PLANNING, ZONING, & BUILDING DEPARTMENT
PZ&B Staff Combination Memorandum: Architectural Commission and Town Council

SUBJECT: ARC-23-117 (ZON-23-091) 341 PERUVIAN AVE (COMBO)

MEETING: SEPTEMBER 27, 2023 | ARCOM
OCTOBER 11, 2023 | TOWN COUNCIL

Existing South Elevation

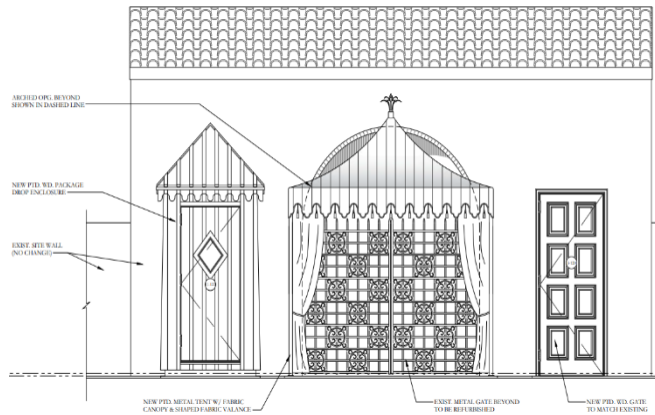
As depicted in the photos, plans, and elevations provided for the project, a large masonry wall structure with a barrel tile roof and three arches exists at the front of property along Peruvian Avenue - east of the residence's south façade. The large central arch contains a decorative metal vehicular gate, and the two flanking arches contain human-scale solid wood panel doors. No alterations are proposed to the south side of the wall.

Proposed North Elevation

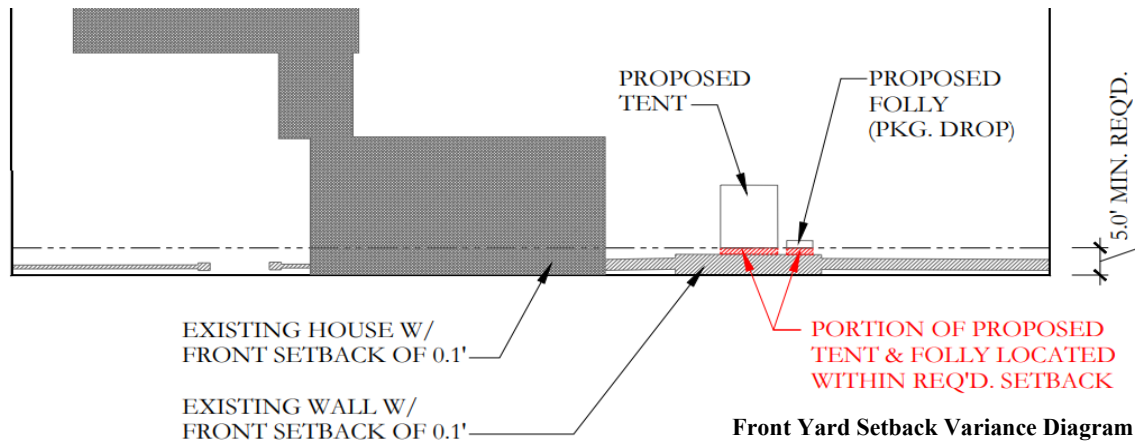
The application requests to install a new metal tent structure with a fabric canopy to provide covered vehicular parking north of the vehicular gate, and a wood package receptacle structure to the north of the east wood panel door. Detailed plan, elevation, and section drawings of the two structures are provided on Sheet A-210 of the architectural plan set. Per the drawings, the package receptacle will not be visible from Peruvian Avenue. The tent structure will be partially visible through the central arch of the wall and through the decorative metal gate.

Front Yard Setback Variance Diagram

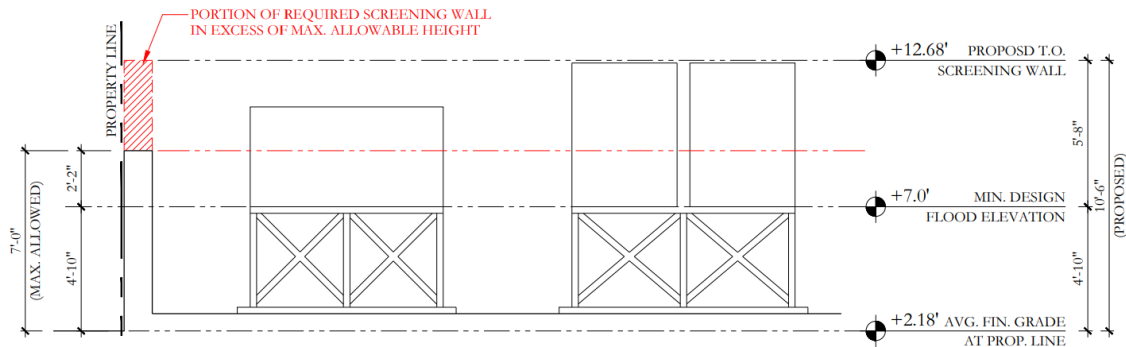
The existing wall structure sits 0.1' off the front property line and is 3.6' deep. The application requests attaching the proposed tent and package receptacle to the north side of the wall, creating front setbacks for these two new elements at 3.7' in lieu of the required 5'-0". As the proposed front setbacks are less than the minimum required, the project requires **Variance 1:**

Code Section	Required	Proposed	Variance
Variance 1: Sec. 134-1113(5)	5'-0" Minimum Front Yard Setback	3.7' Front Yard Setback	3.3' Encroachment
